PLANNING COMMISSION REPORT
Non-Public Hearing Item

PC Staff Report
07/25/16

**ITEM NO. 6 FINAL DEVELOPMENT PLAN FOR PETSMART, BAUER FARM; 4820
BAUER FARM DR (SLD)**

FDP-16-00216: Consider a Final Development Plan for PetSmart, located at 4820 Bauer Farm Dr. The plan proposes a new 18,000 sq. ft. building west of Sprout's. Submitted by Treanor Architects, for Wakarusa Investors, LLC, property owner of record.

Figure 3: Proposed FDP Landscape/Access Plan

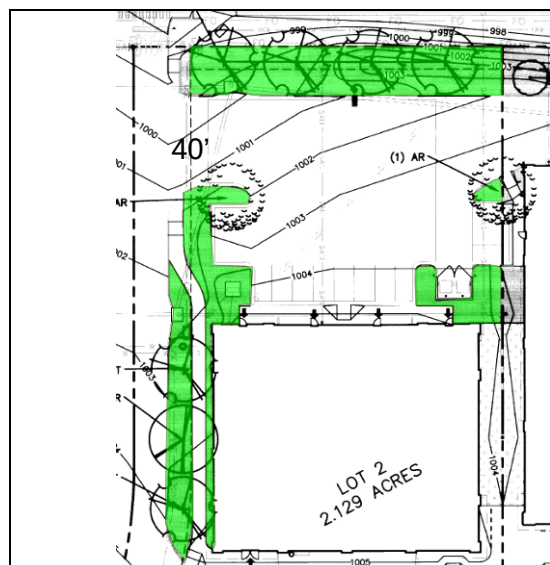
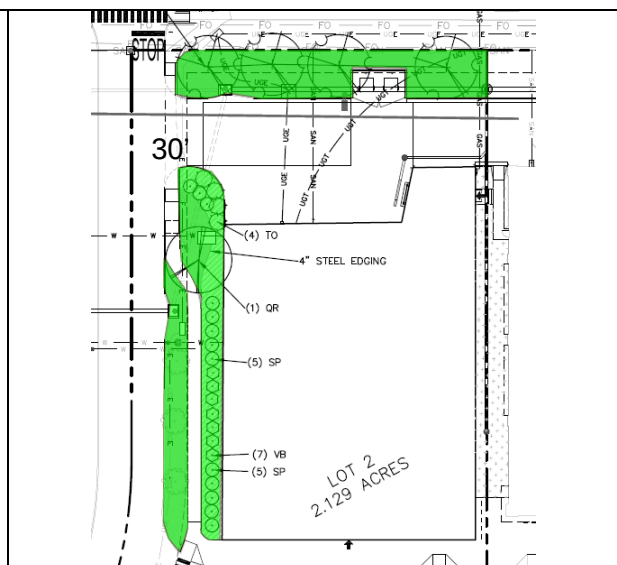
This proposed project does not alter the interior green space of the parking lot. The area affected by the proposed building increase is located in the northwest corner of Lot 2. The following graphic shows the approved and proposed changes to the green spaces within the site that result from the change to the building footprint.

Greenspace is added along the private street and the delivery drive on the north side of the site is reduced from 40' to 30'. Green space along the west side of the building has also been increased. These elements will enhance the pedestrian experience of the site.

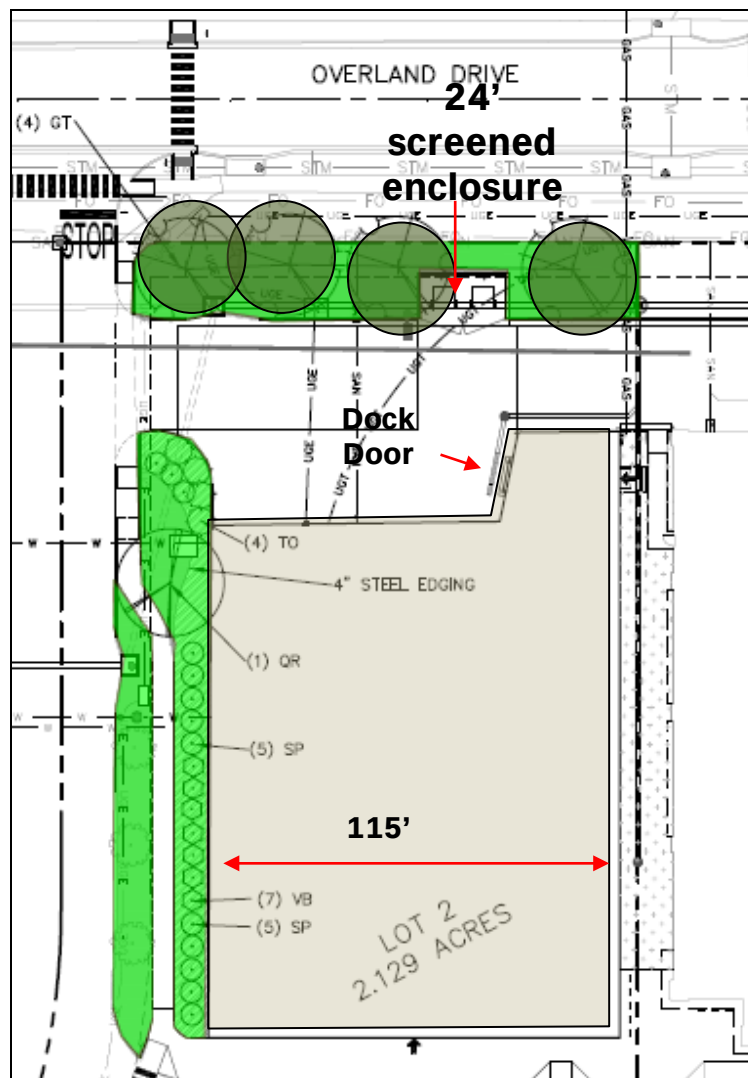
However the Sprouts site has made use of this space for both smaller deliveries and for storage as seen in the following pictures.

The trash enclosure for the proposed building will provide 24' of screening along the rear of the building specifically in the area of the loading dock. The orientation of the loading dock is toward the private street rather than facing Overland Drive as in the Sprouts example above. Street trees along Overland Drive have been installed for both Lots 2 and 3 and are shown on the attached Final Development Plan.

Screening is needed when there are frequent deliveries, storage of materials or trash enclosures in a particular area. Prohibiting storage within the delivery area would facilitate the use of the space per the approved plans. The addition of a screening wall or dense landscape would result in providing an appropriate visual aesthetic for the surrounding area. While sprouts is not included in this application is exemplifies the concerns.

Screening walls can be provided but must maintain a minimum separation from utilities, specifically the sanitary sewer. The plan also shows a proposed transformer to be located in the rear of the property. These utility boxes are quite large and should also be appropriately screened.

Staff recommends that a dense landscape screen provided along the north side of Lot 2 to provide additional screening. Shrubs, located in groupings, between street trees will provide adequate screening. Staff also recommends that a note be added to the plan that prohibits the outdoor storage of equipment, supplies, materials, and similar item within the access drive on the north side of the property.

Figure 4: Looking West

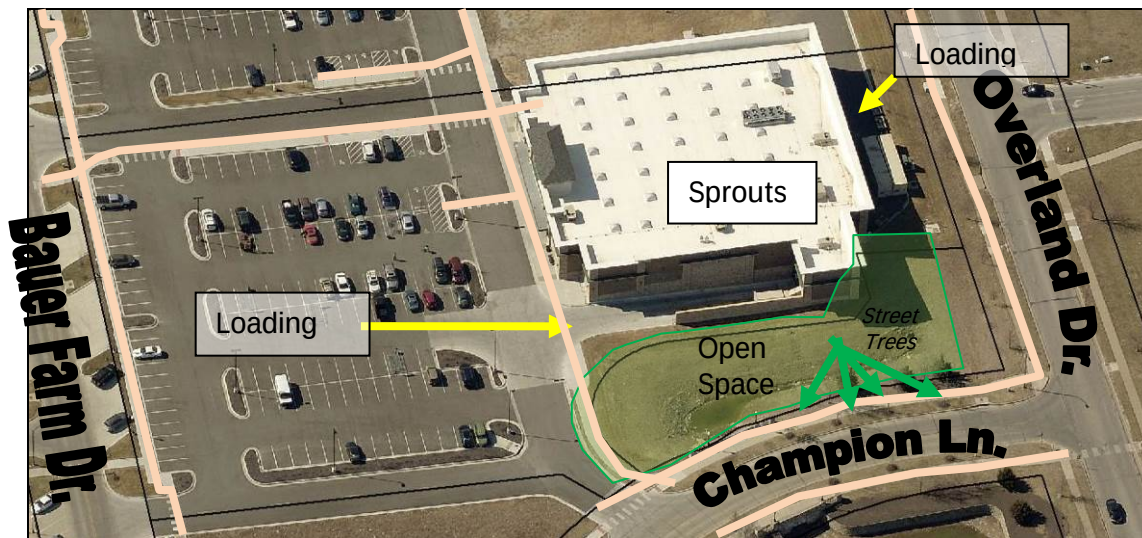
Delivery access to Lots 2 and 3 were approved along the private street with a 40' wide driveway intended to serve both buildings. The sprout's building was approved with delivery access to the side of the building as well. However, that east side of the building is separated by a drainage easement (dedicated open space) with a standard public sidewalk that is separated from the street with a tree lawn.

Figure 5: Looking East

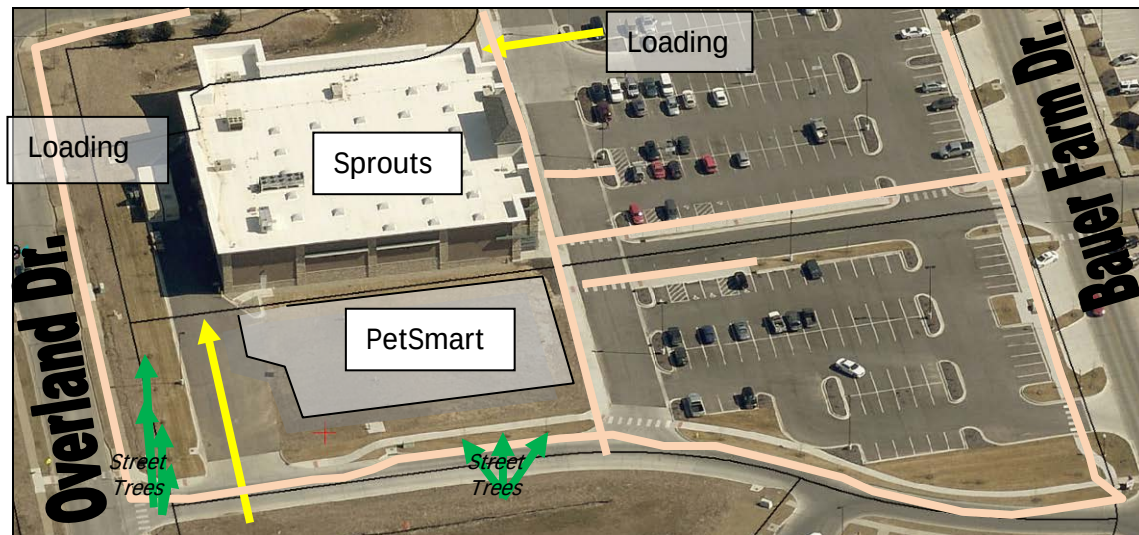
This Final Development Plan includes a reconfigured building footprint with a rear loading dock area that incorporates the existing north driveway as shown in Figure 3 above.

Figure 7: Proposed FDP with 18,000 SF building

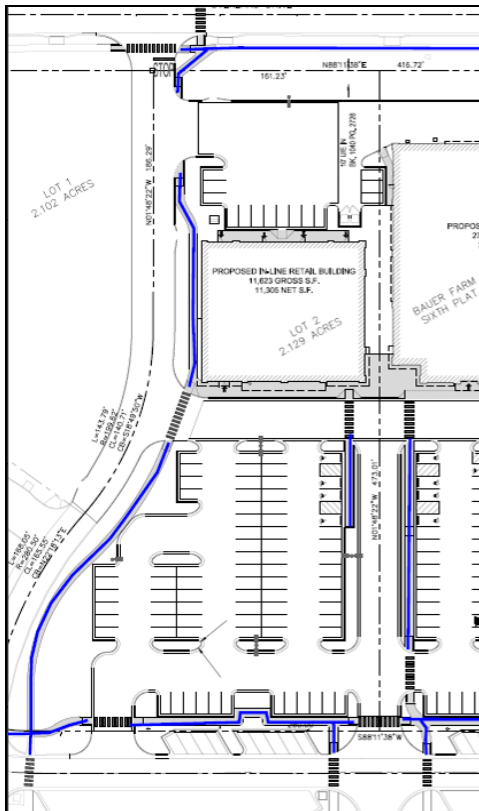
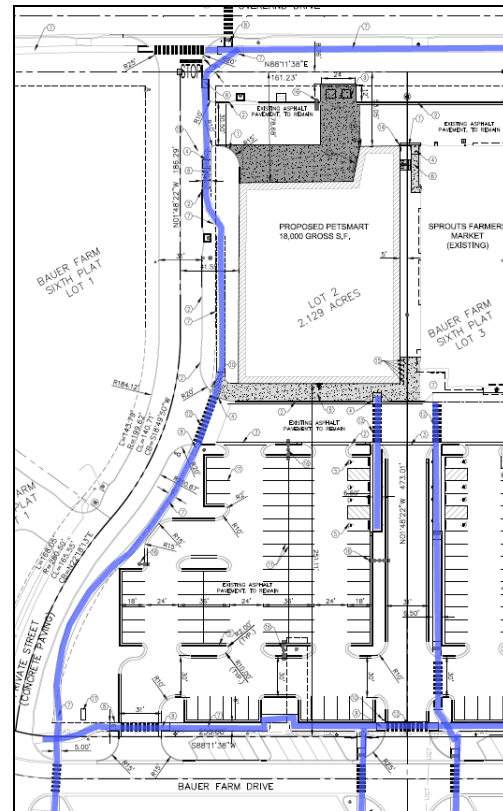
Internal pedestrian walkways are provided throughout the development. The plan shows pedestrian connections within the site and connecting to existing public sidewalks surrounding the property. The original approval oriented the Sprouts building and the future commercial building along a common shared drive and parking lot area with a shared area accessed from the private street on the west side. This design provided a connected pedestrian pathway along the west side of the commercial building with a public sidewalk separated from the street with a green space as shown in the following figure on the left.

The revised plan, with the bigger building creates two driveways along the private street and relocates the sidewalk to the back of the street curb and reduces the green space. The interior pedestrian sidewalks are not changed with this application with the exception noted.

Figure 10: Exterior Side Elevation

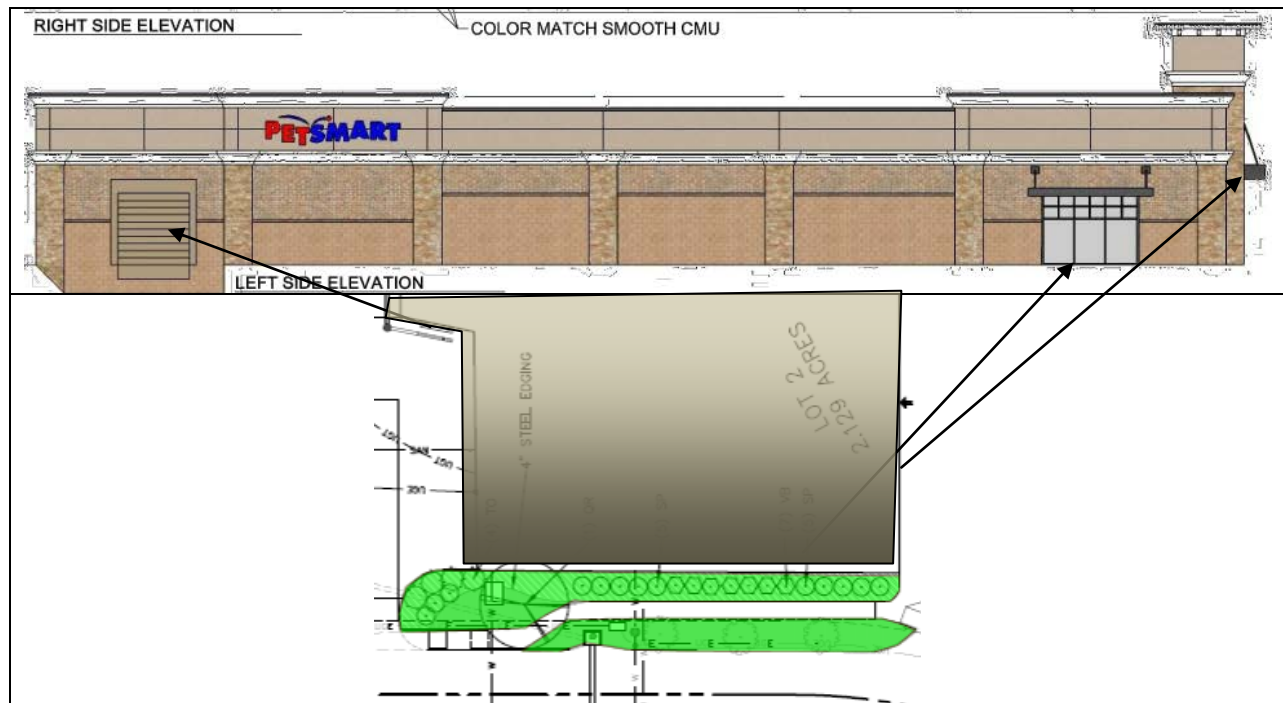
Exterior Side Façade: The exterior side of the building is softened with the landscape areas along the private street that accommodates street trees and an existing sidewalk.

Figure 11: Rear Elevation

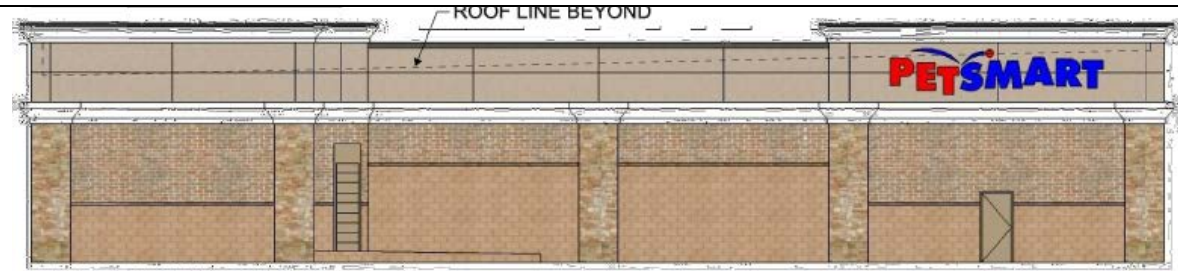
Rear Façade: The rear of the building is oriented to Overland Drive and was discussed with the landscape section previously in this staff report. The loading dock is oriented to the private street and is setback into the site providing significant separation from the pedestrian pathways along the west side of the building. The picture below (top) shows the proposed building façade that would face Overland Drive. The picture below (bottom) shows the existing Overland Drive street scape with a portion of the Sprouts façade visible.

The building materials and pattern of the front of the building are continued on all sides. The addition of landscape shrubs would mitigate the activity associated with the commercial use from delivery vehicles and enhance the pedestrian experience of Overland Drive.

SITE LAYOUT PLAN

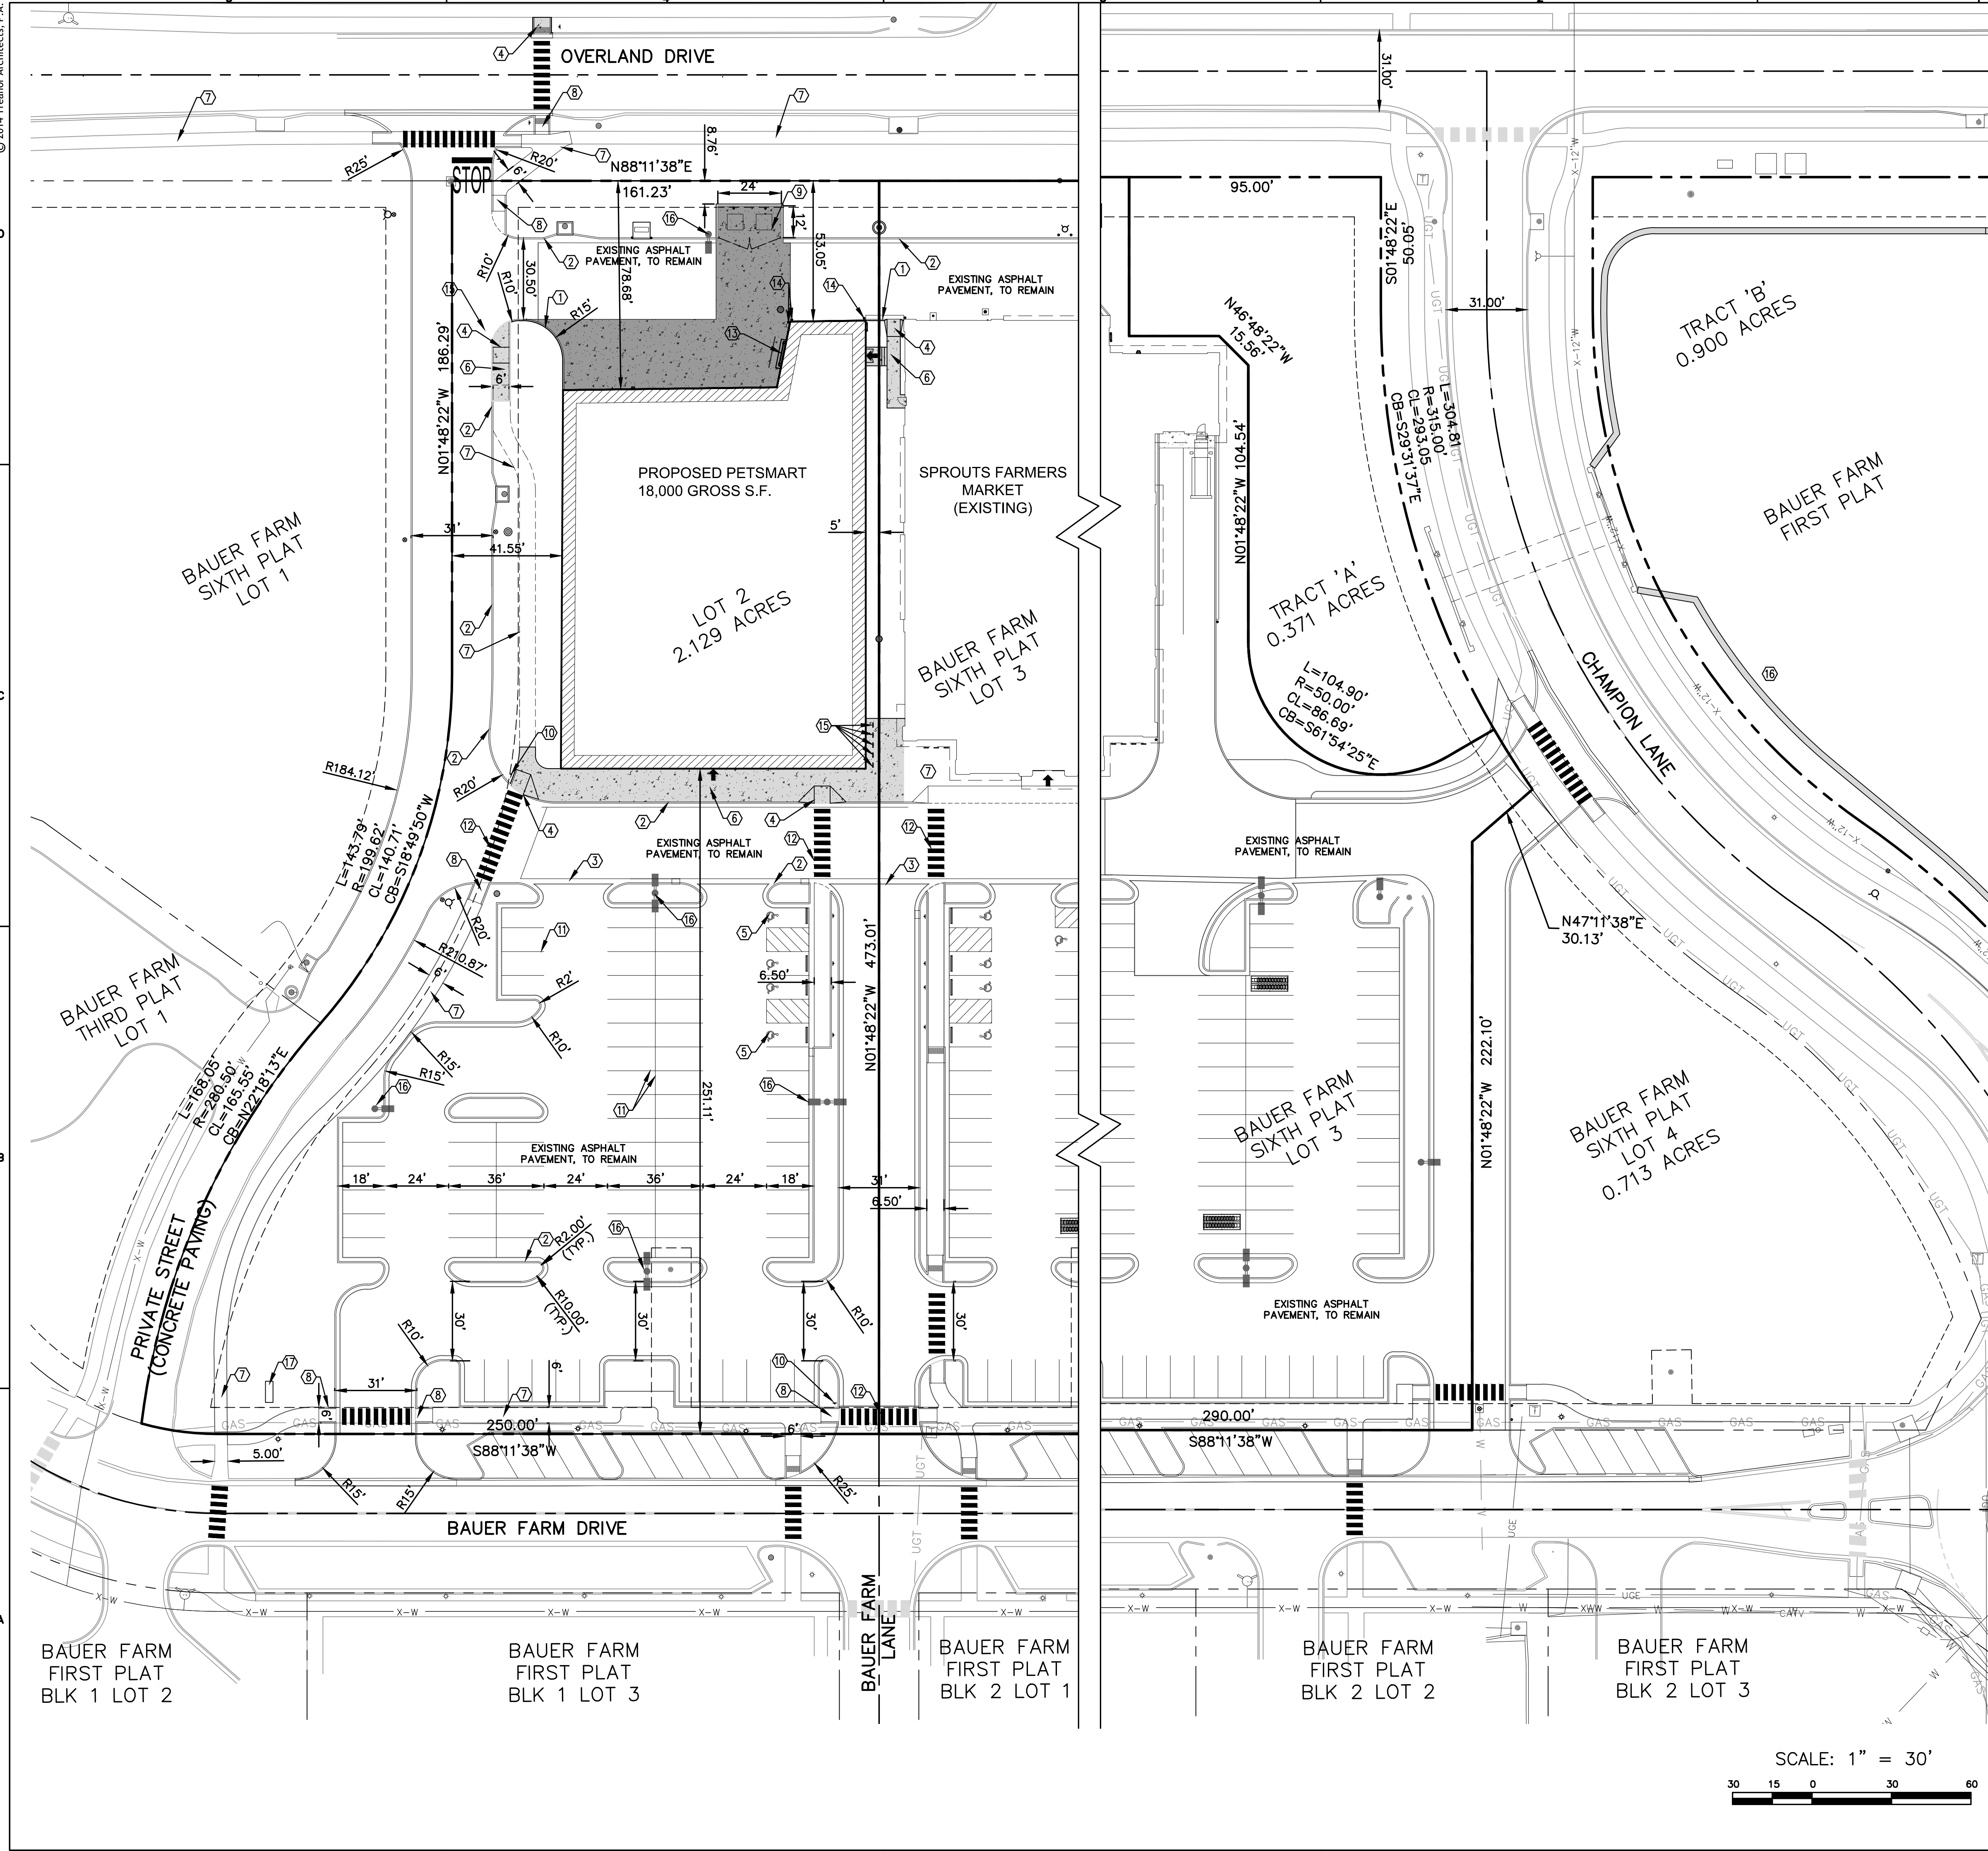
- The Final Development Plan as proposed exceeds the commercial cap of 50,000 SF as summarized below. The note should be revised to clearly state that the maximum allowed retail SF for Lot 4 is restricted.

Required off-street parking needs to be shown uniformly per the previous methods of parking calculations shown for this development. Staff recommends the parking be revised to show the

Net Square Feet of the proposed building and a revised parking table consistent with the standard accounting of 1 space per 200 NSF for this development

- 67 spaces required
- 77 spaces provided
